August 16, 1996 - EPC Findings and Conditions and Responses for File Z-96-96:

Amended Master Site Plan
and Site Development Plan
for Building Permit
Project #1000546 03DRB-00732 & 03DRB-00711

City of Albuquerque
Parks and Recreation Department
Phil Chacon Park and
New Mexico Veterans' Memorial

May 2, 2003

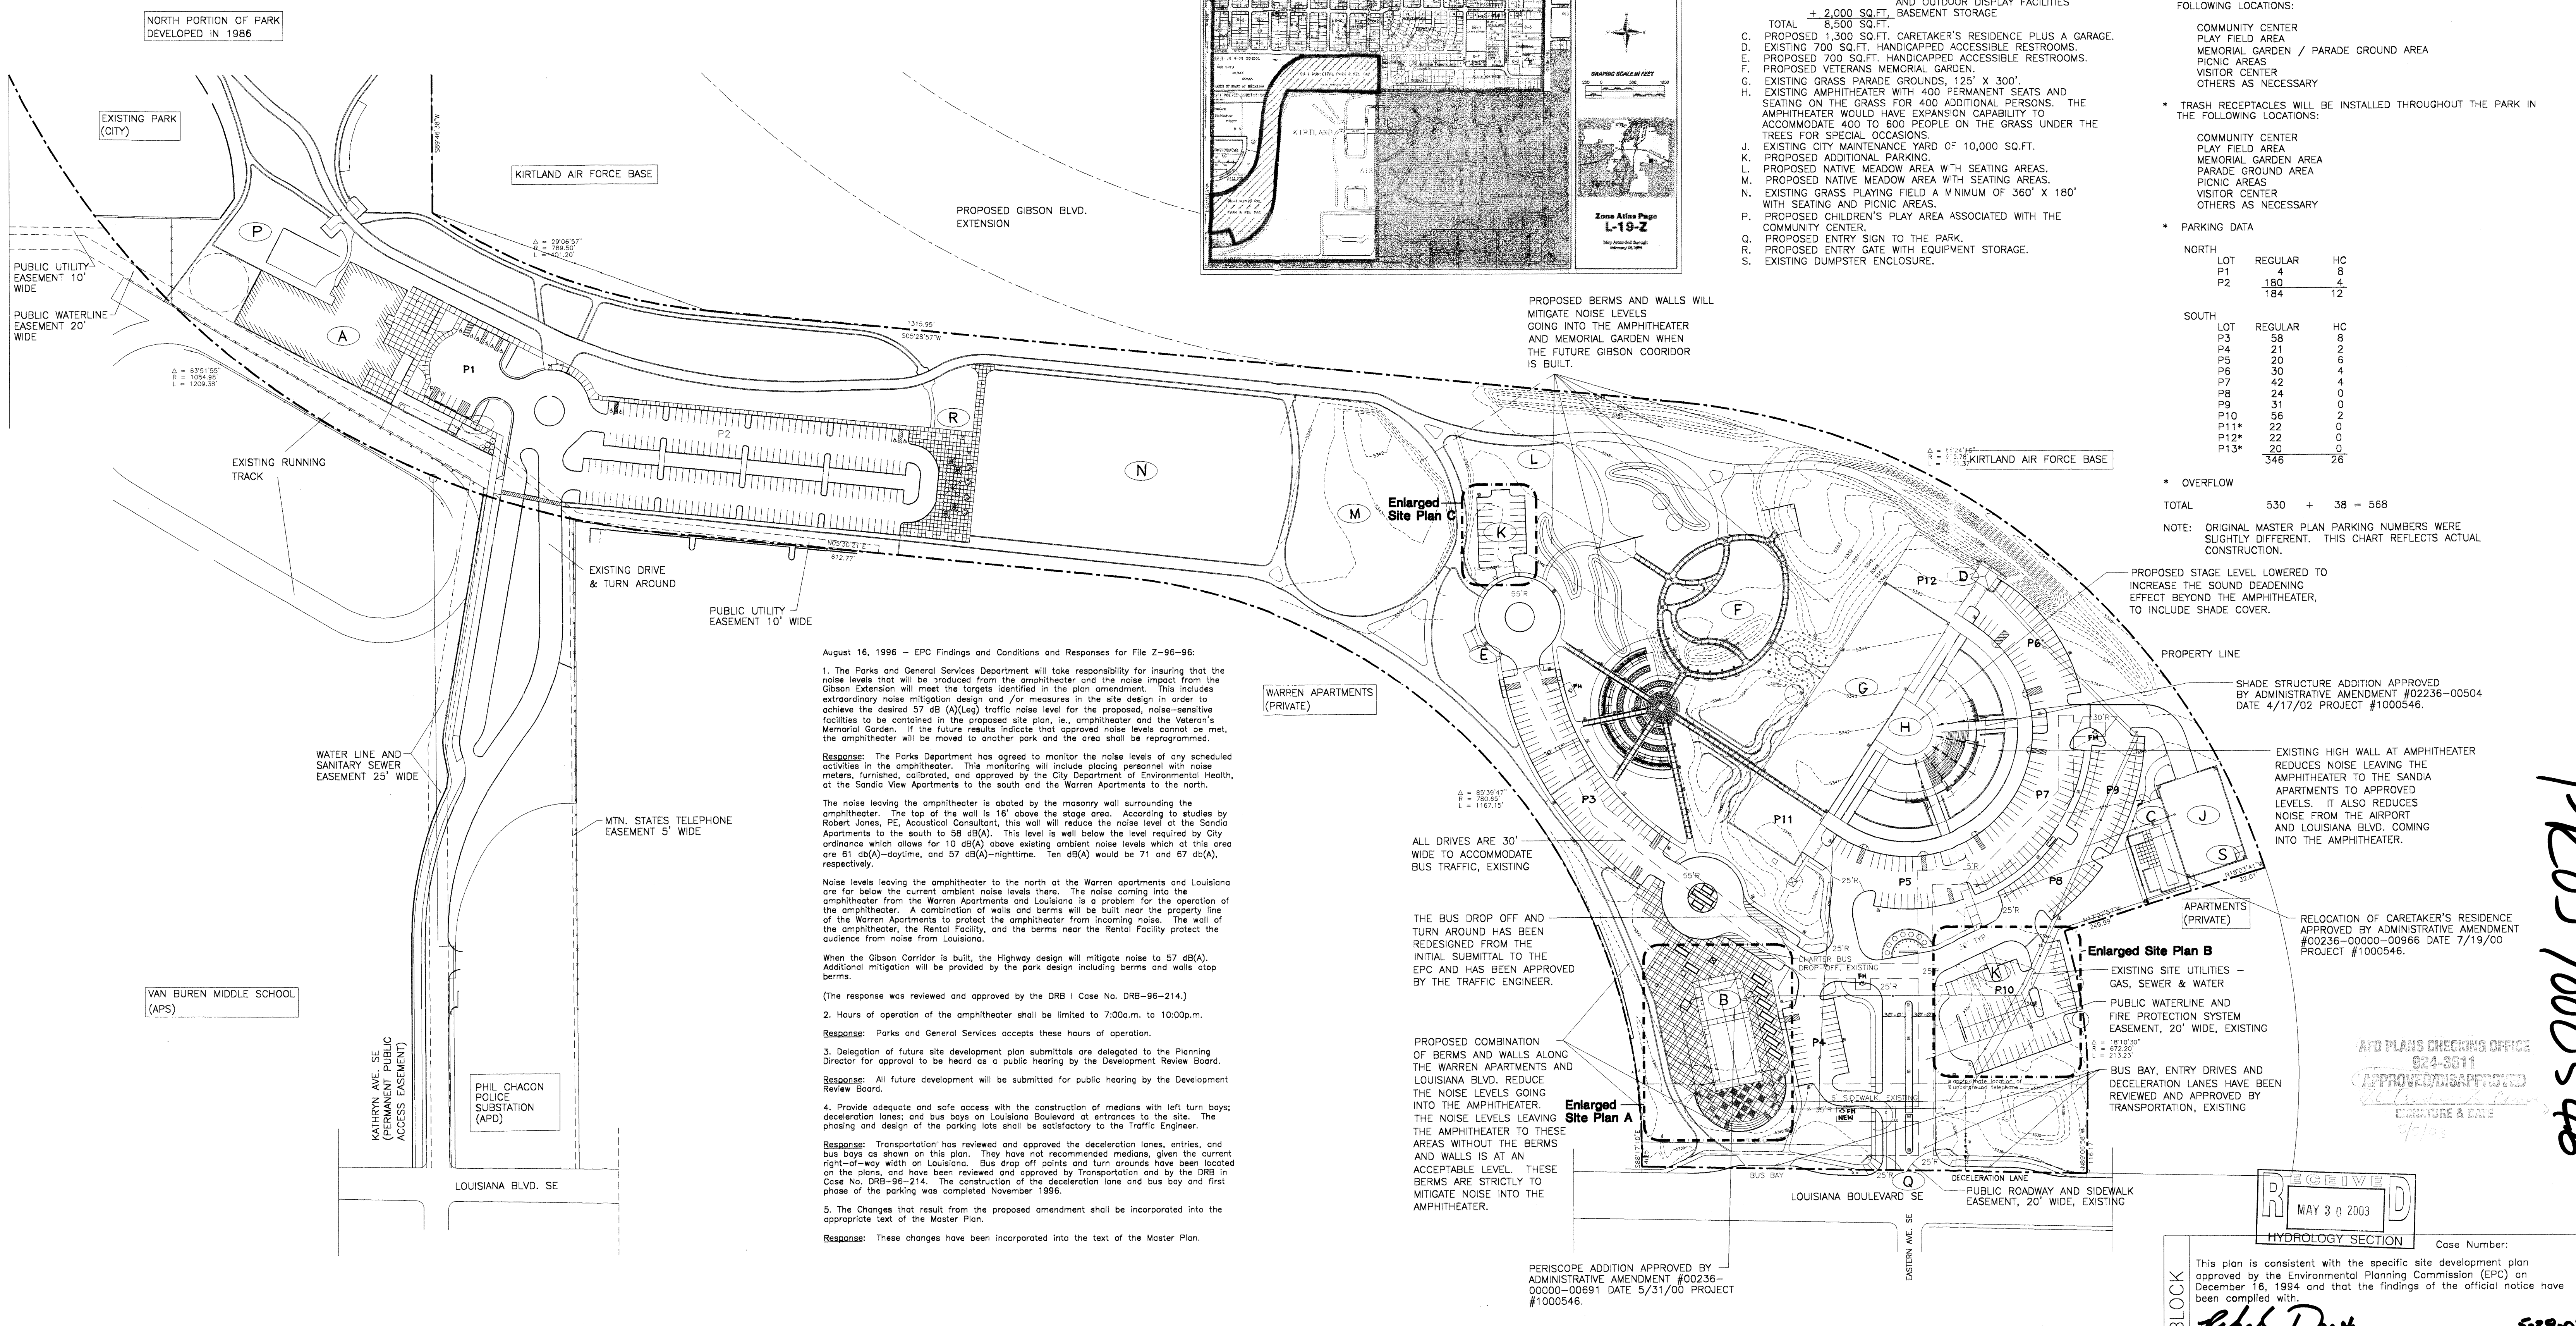
1. The Parks and General Services Department will take responsibility for insuring that the noise levels that will be produced from the amphitheater and the noise impact from the Gibson Extension will meet the targets identified in the plan amendment. This includes extraordinary noise mitigation design and/or measures in the site design in order to achieve the desired 57 dB(A)(Leg) traffic noise level for the proposed, noise-sensitive facilities to be contained in the proposed site plan, i.e., amphitheater and the Veterans' Memorial Garden. If the future results indicate that approved noise levels cannot be met, the amphitheater will be moved to another park and the area shall be reprogrammed.

2. Hours of operation of the amphitheater shall be limited to 7:00a.m. to 10:00p.m.

3. Delegation of future site development plan submittals are delegated to the Planning Director for approval to be heard as a public hearing by the Development Review Board.

4. Provide adequate and safe access with the construction of medians with left turn bays; deceleration lanes; and bus bays on Louisiana Boulevard at entrances to the site. The pricing and design of the parking lots shall be satisfactory to the Traffic Engineer.

5. The Changes that result from the proposed amendment shall be incorporated into the appropriate text of the Master Plan.

Response: The Parks Department has agreed to monitor the noise levels of any scheduled activities in the amphitheater. This monitoring will include placing personnel with noise meters, furnished, calibrated, and approved by the City Department of Environmental Health, at the Sandia View Apartments to the south and the Warren Apartments to the north.

The noise leaving the amphitheater is abated by the masonry wall surrounding the amphitheater. The top of the wall is 16' above the stage area. According to studies by Robert Jones, PE, Acoustical Consultant, this wall will reduce the noise level at the Sandia Apartments to the south to 58 dB(A). This level is well below the level required by City ordinance which allows for 10 dB(A) above existing ambient noise levels which at this area are 61 dB(A)-daytime, and 57 dB(A)-nighttime. Ten dB(A) would be 71 and 67 dB(A), respectively.

Noise levels leaving the amphitheater to the north at the Warren apartments and Louisiana are far below the current ambient noise levels there. The noise coming into the amphitheater from the Warren Apartments and Louisiana is a problem for the operation of the amphitheater. A combination of walls and berms will be built near the property line of the Warren Apartments to protect the amphitheater from incoming noise. The wall of the amphitheater, the Rental Facility, and the berms near the Rental Facility protect the audience from noise from Louisiana.

When the Gibson Corridor is built, the Highway design will mitigate noise to 57 dB(A). Additional mitigation will be provided by the park design including berms and walls atop berms.

Response: Parks and General Services accepts these hours of operation.

Response: All future development will be submitted for public hearing by the Development Review Board.

Response: Transportation has reviewed and approved the deceleration lanes, entries, and bus bays as shown on this plan. They have not recommended medians, given the current right-of-way width on Louisiana. Bus drop off points and turn arounds have been located on the plans, and have been reviewed and approved by Transportation and by the DRB in Case No. DRB-96-214. The construction of the deceleration lane and bus bay and first phase of the parking was completed November 1996.

Response: These changes have been incorporated into the text of the Master Plan.
